Application for Works Approval Amendment

Works Approval Number	W6689/2022/1
Works Approval Holder	Kalgoorlie Consolidated Gold Mines Pty Ltd
ACN	009 377 619
File Number	DER2022/000170
Premises	<p>Fimiston Processing Plant</p> <p>Tenements M26/383, M26/294, M26/359, M26/86, M26/46, L26/216, L26/217, G26/159</p> <p>KALGOORLIE WA 6430</p> <p>As defined by the premises map attached to the issued works approval</p>
Date of Report	18/07/2024
Decision	Revised works approval granted

Works Approval: W6689/2022/1

Figure 2: Fimiston Processing Plant – Distance from Receptors

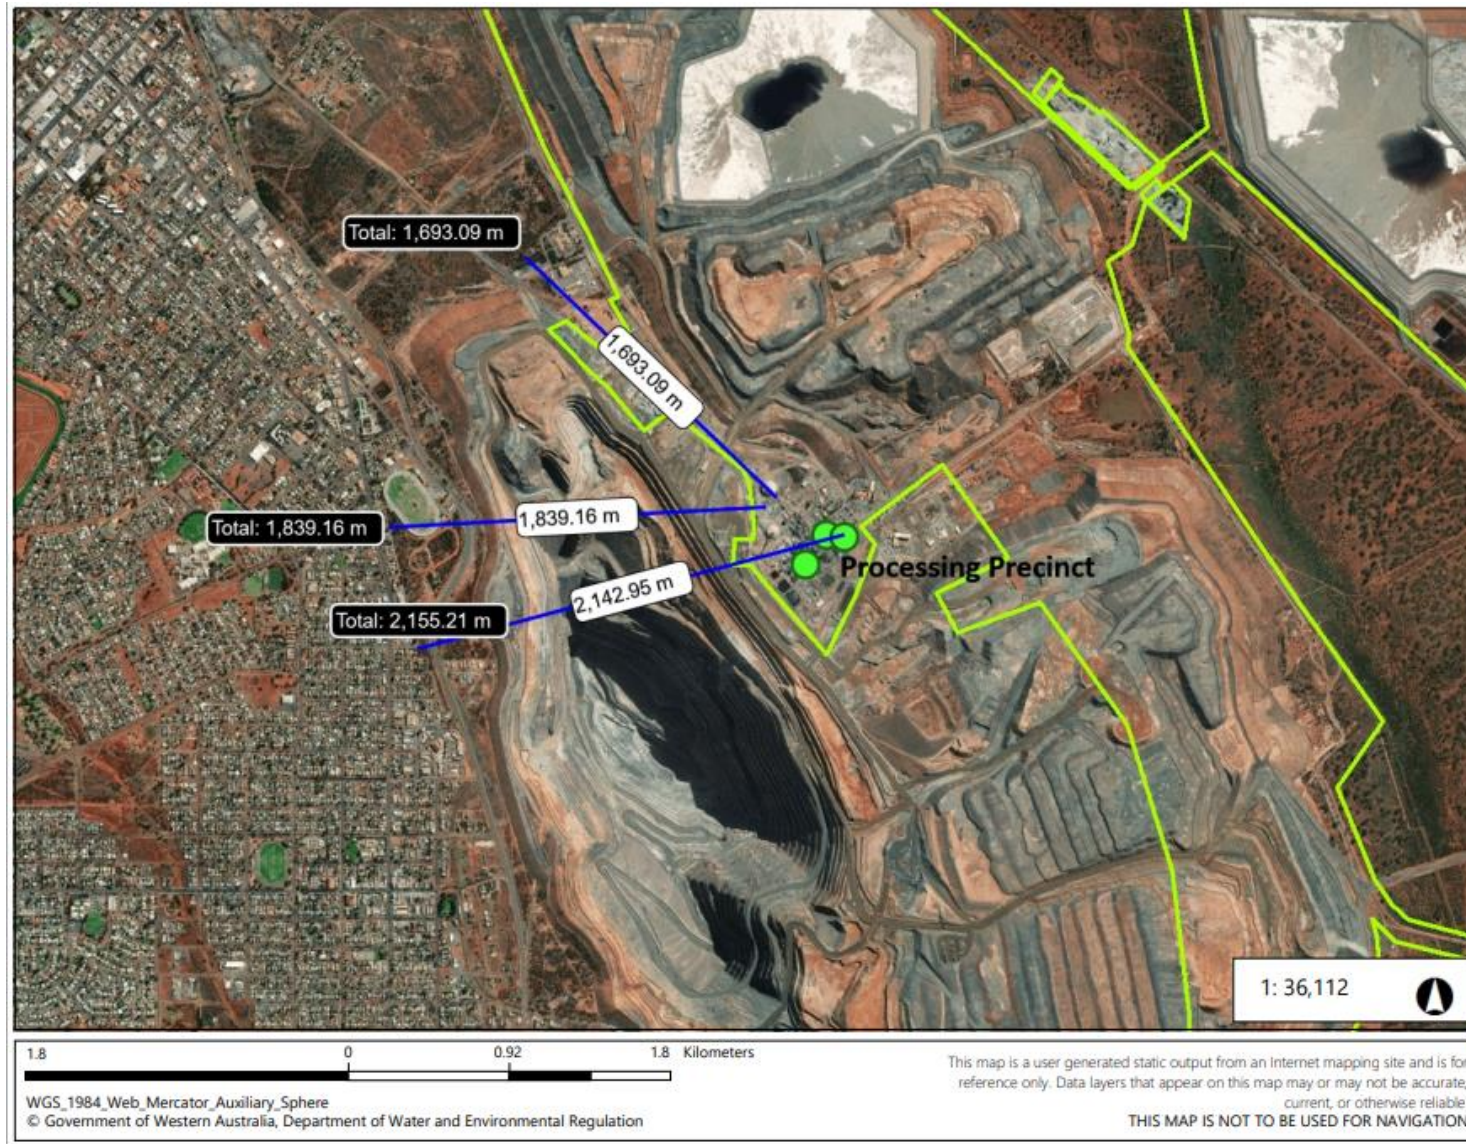
Table 3 and Figure 2 below provides a summary of potential human and environmental receptors that may be impacted as a result of activities upon or emission and discharges from the prescribed premises (*Guideline: Environmental siting* (DWER 2020a)).

Figure 3a-3d: Modelled Emissions Scenarios – 23.5 Mtpa and 30 Mtpa comparison

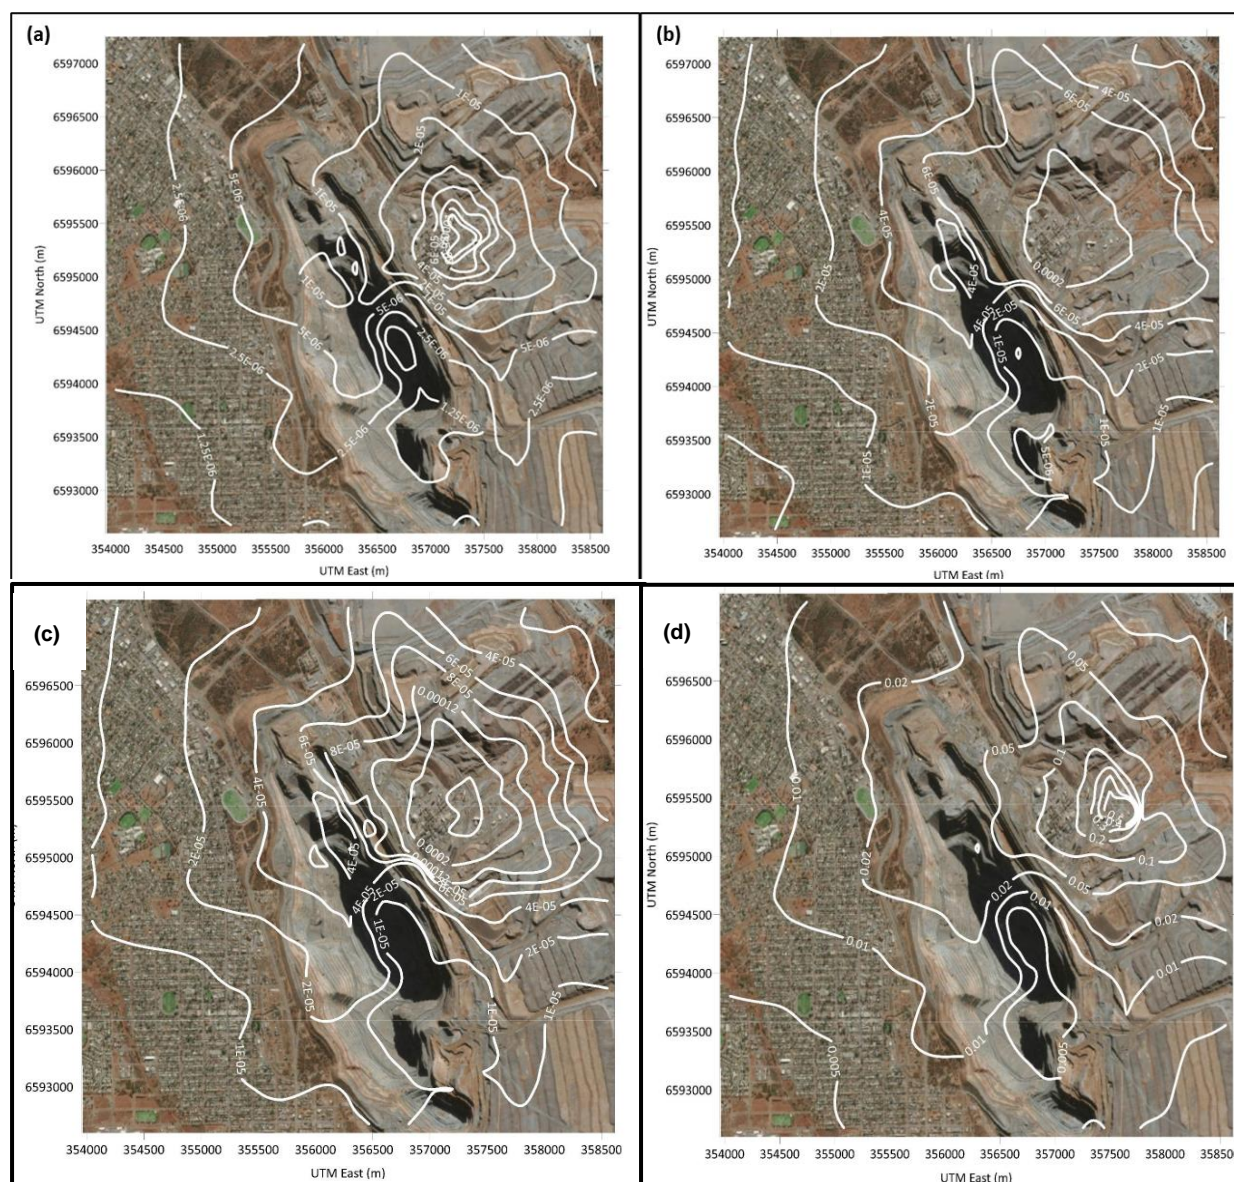
The mercury and benzene emissions under the 23.5 Mtpa assessment, based on a stack height of 20 metres, are shown in Figure 3a and Figure 3c, respectively (DWER 2022). The updated emissions in this proposed amendment for mercury and benzene emissions, based on a stack height of 35 metres, are shown in Figure 3b and Figure 3d, respectively.

Results indicated that the maximum predicted ground level concentrations (GLC) of the emission profile from the kiln stacks was increased as a result of increasing processing throughput from 23.5 Mtpa to 30 Mtpa. This increase in emission concentrations was also observed at offsite sensitive receptors, despite increasing the proposed stack height to 35 metres. Predicted mercury concentrations had increased more significantly, compared to benzene concentrations (Table 6).

The predicted GLCs modelled for the 30 Mtpa plant remained relatively low compared to the relevant ambient air quality guideline values (AGVs) (Table 6). Despite the significant increase observed as part of the proposed upgrades to 30 Mtpa, predicted mercury GLCs were less than 1% of the relevant mercury AGV on an hourly and annual basis. Despite a smaller level of increase observed for benzene GLCs in increasing processing throughput to 30 Mtpa, the predicted concentrations were higher, in relation to the relevant AGV, with hourly average benzene GLC being 11% of the AGV.

- When setting a stack height of 35 m and excluding an RTO in the proposed KOGCC design, the predicted onsite and offsite GLCs for mercury and benzene in the current assessment at 30 Mtpa are greater than those for the 23.5 Mtpa plant;
- However, predicted GLCs for mercury and benzene were still within the respective ambient air quality guidelines (AGVs).

Note: Annual average predicted ground level concentration ($\mu\text{g}/\text{m}^3$) of (a) mercury and (c) benzene under Scenario 2 with 20 m stack height based on throughput of 23.5 Mtpa. Annual average predicted ground level concentrations $\mu\text{g}/\text{m}^3$ of (b) mercury and (d) benzene under Scenario 2 with 35 m stack height. Stack height for (b) mercury was not specified.

All emissions of potential concern remain within relevant guideline values and do not present an unacceptable risk to nearby receptors. As such, the Delegated Officer has decided that no additional operational controls are required to manage air emissions from the premises.
